Wollongong Local Planning Panel Assessment Report | 12 December 2018

WLPP No.	Item 4
DA No.	DA-2017/1064
Proposal	Mixed use residential development - Phase 1: demolition of existing dwelling, tree removals and construction of a two storey residential flat building containing 12 apartments plus basement parking, a two storey dwelling, riparian area works, driveway and bridge access Phase 2: construction of a two storey residential flat building containing 16 apartments plus basement parking
Property	39 Angel Street Corrimal, Lot 56 DP 27796
Applicant	ADM Architects
Responsible Team	Development Assessment and Certification - City Wide Team (KR)

ADDENDUM REPORT

BLOCK A BASEMENT PLAN

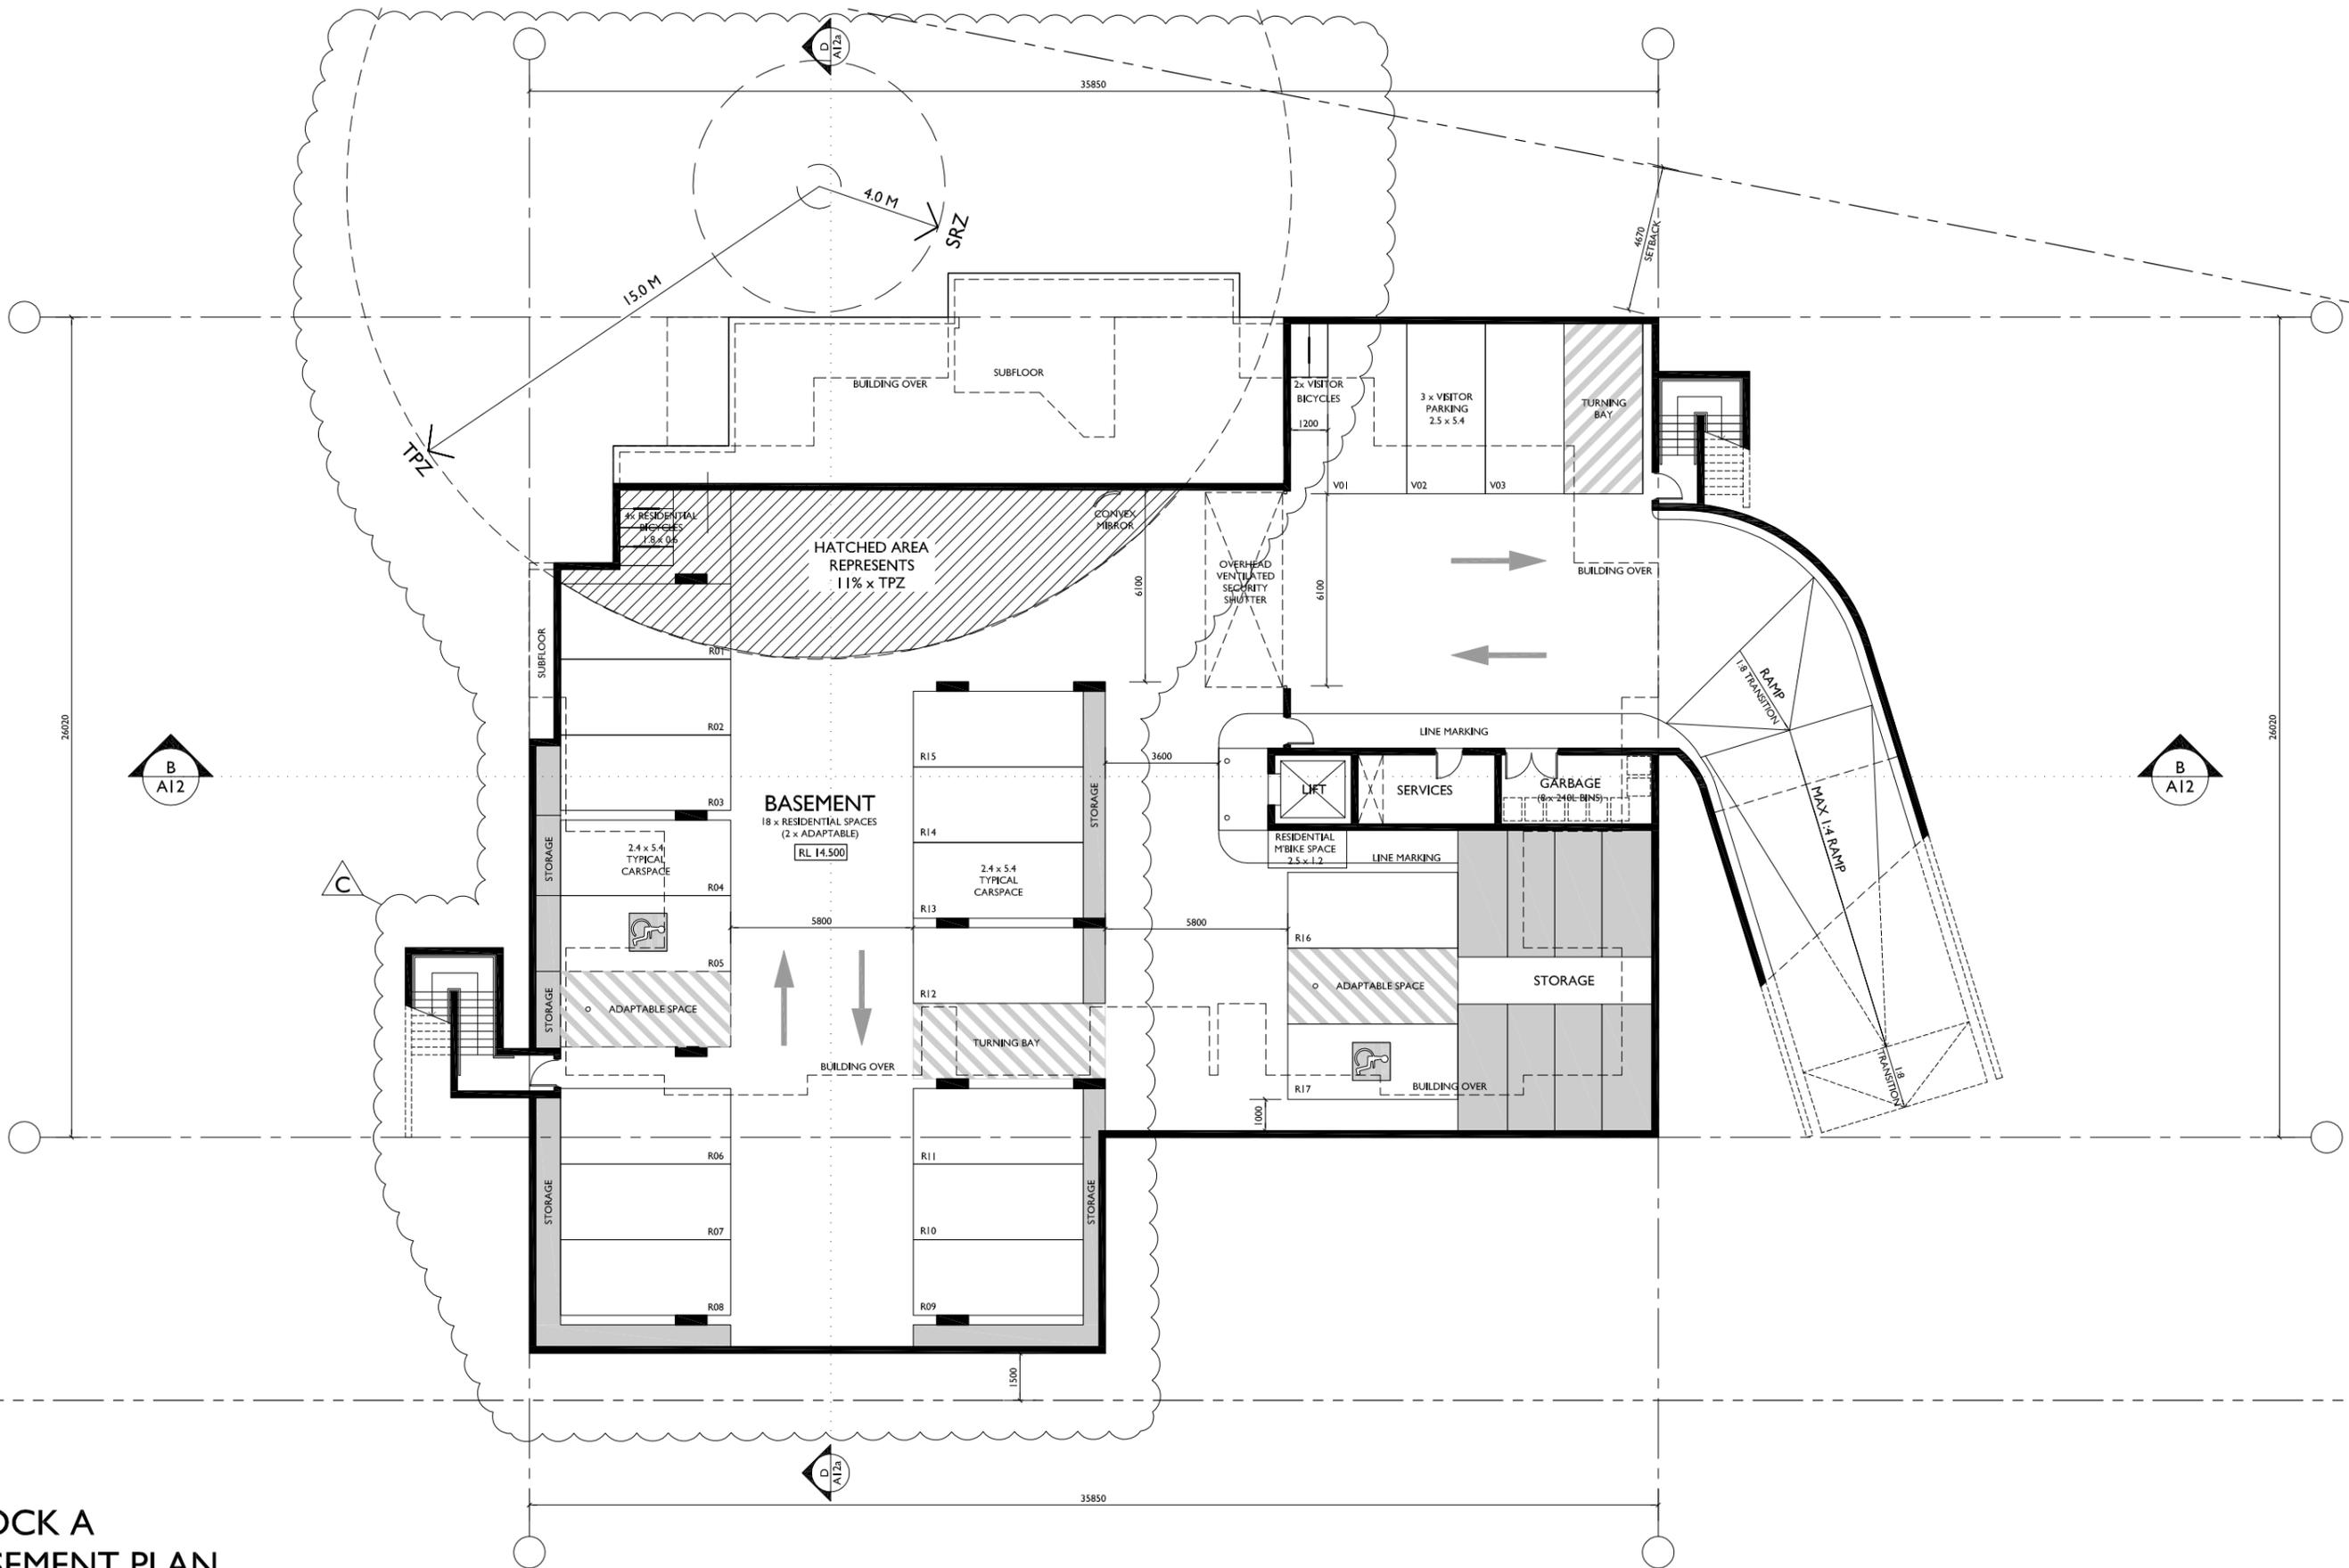
Based on the basement depth, approximately 3000mm below grade, this excavation will remove all root system contained in the proportion of encroachment (see Drawing A07 (C)). This encroachment is three percentage points in excess of a minor encroachment and is not considered to pose any significant impact on the tree. Accounting for Assumption 1, this is likely less.

BLOCK B BASEMENT PLAN

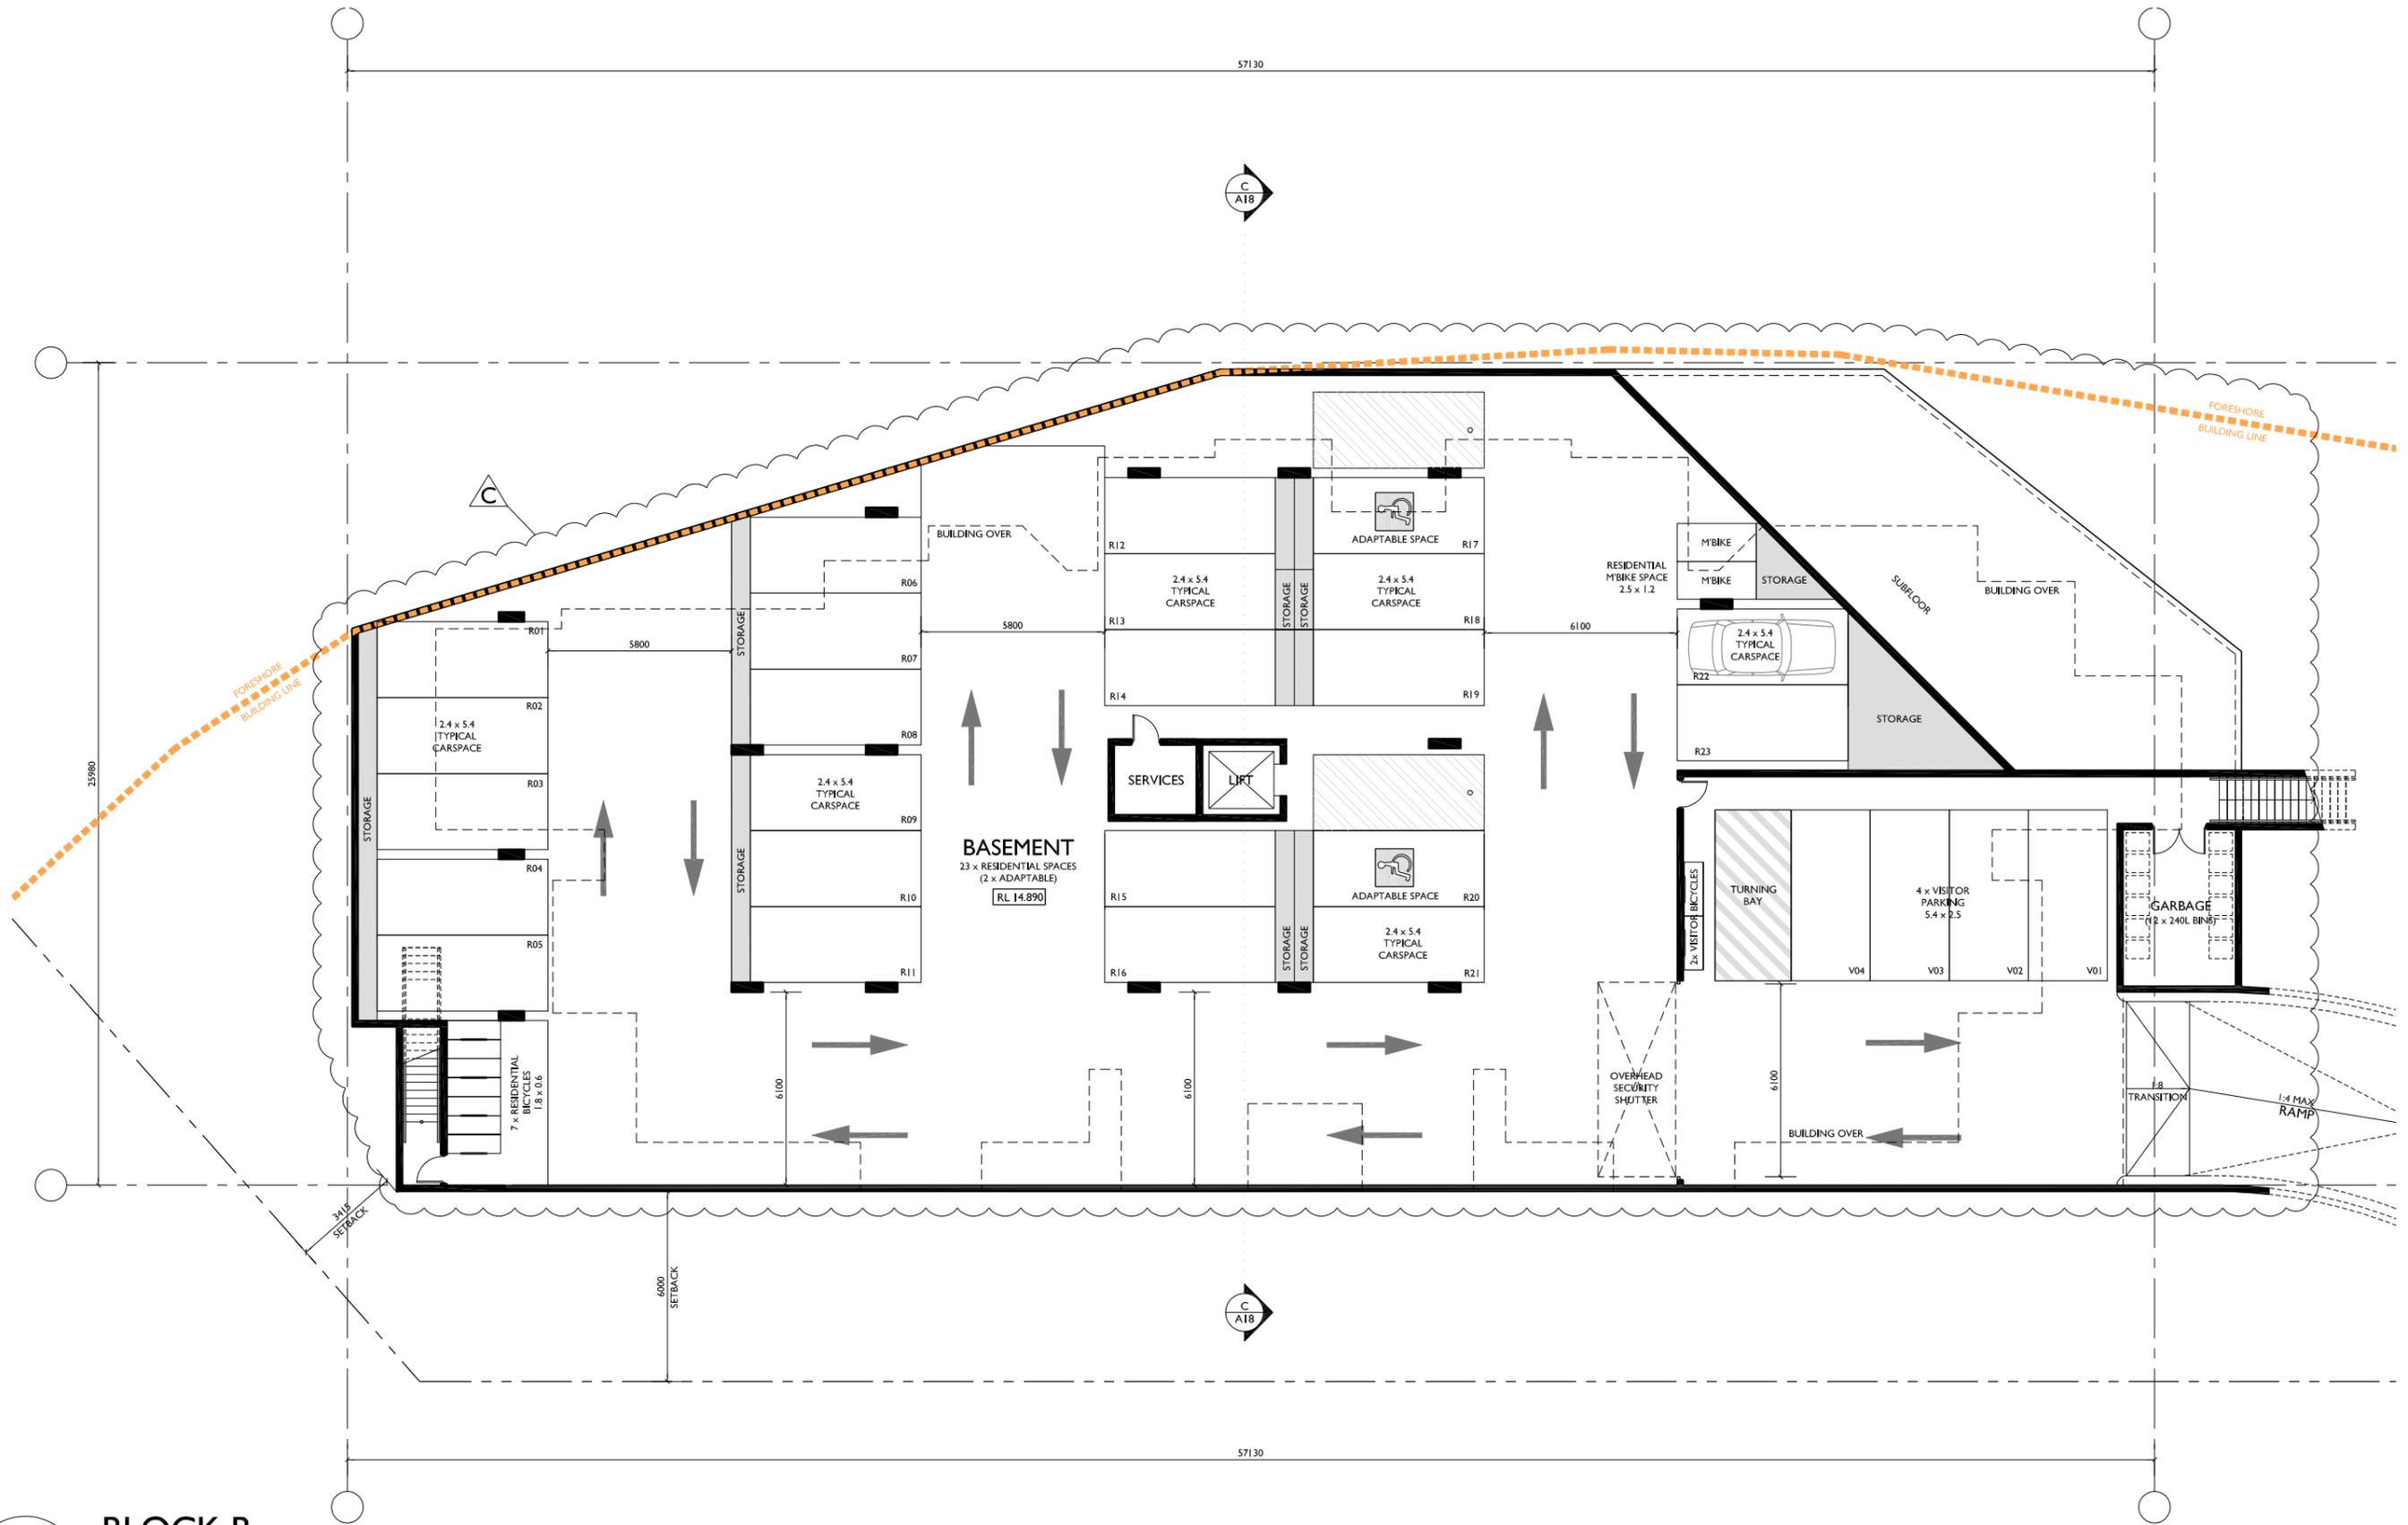
In response to the Panel's concerns the applicant has amended Block B to remove the encroachment into the foreshore building line. This has involved:

- Reducing the size of the basement level to remove the encroachment into the foreshore building line.
- Reduction of parking provided in Block B by 1 space from 24 to 23, and reduction of residential bicycle parking facilities by 1 space from 8 to 7.
- Changes to Ground Floor and First Floor Plan with some units reduced/redesigned.

The applicant has revised the basement level which has resulted in the loss of one parking space (reduction from 24 spaces to 23 spaces). The Ground Floor and Level 1 Plans for Block B were also revised with amendment to the layout of some of the units including reducing the size of Units B01 and B09 to less than 70sqm to reduce the required parking. Block B has 16 units of which 2 are less than 70sqm and 14 are between 70-110sqm in floor area. The amended proposal complies with the parking requirements of Chapter E3 Schedule 1 as follows:

BLOCK A
TREE SECTION DD

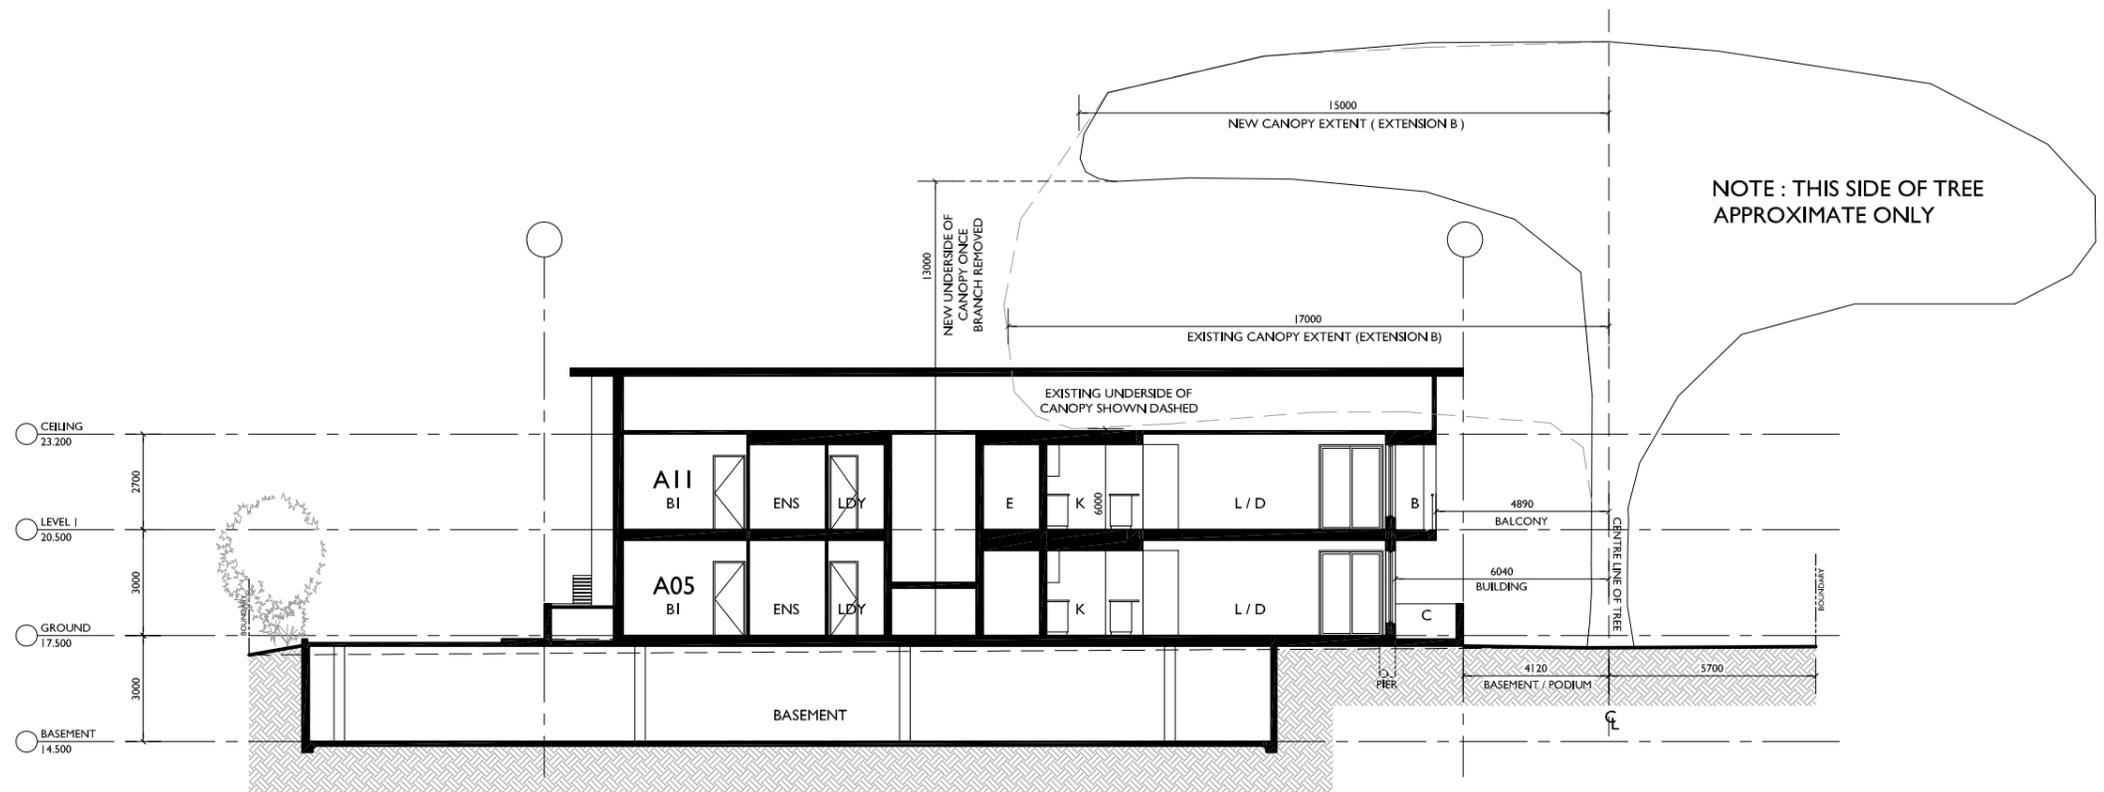
The encroachment associated with the remaining footprint is not considered to render a significant impact. This is based on the grade of the proposed floor to be elevated above the natural grade (see Drawing A12a (C)), therefore removing any excavation required for this area and allowing gas exchange with the retained grade. The means of support have been illustrated as a pier and cantilevered. The floor area within this area of the design will require the following conditions so that the root system in this area is retained;
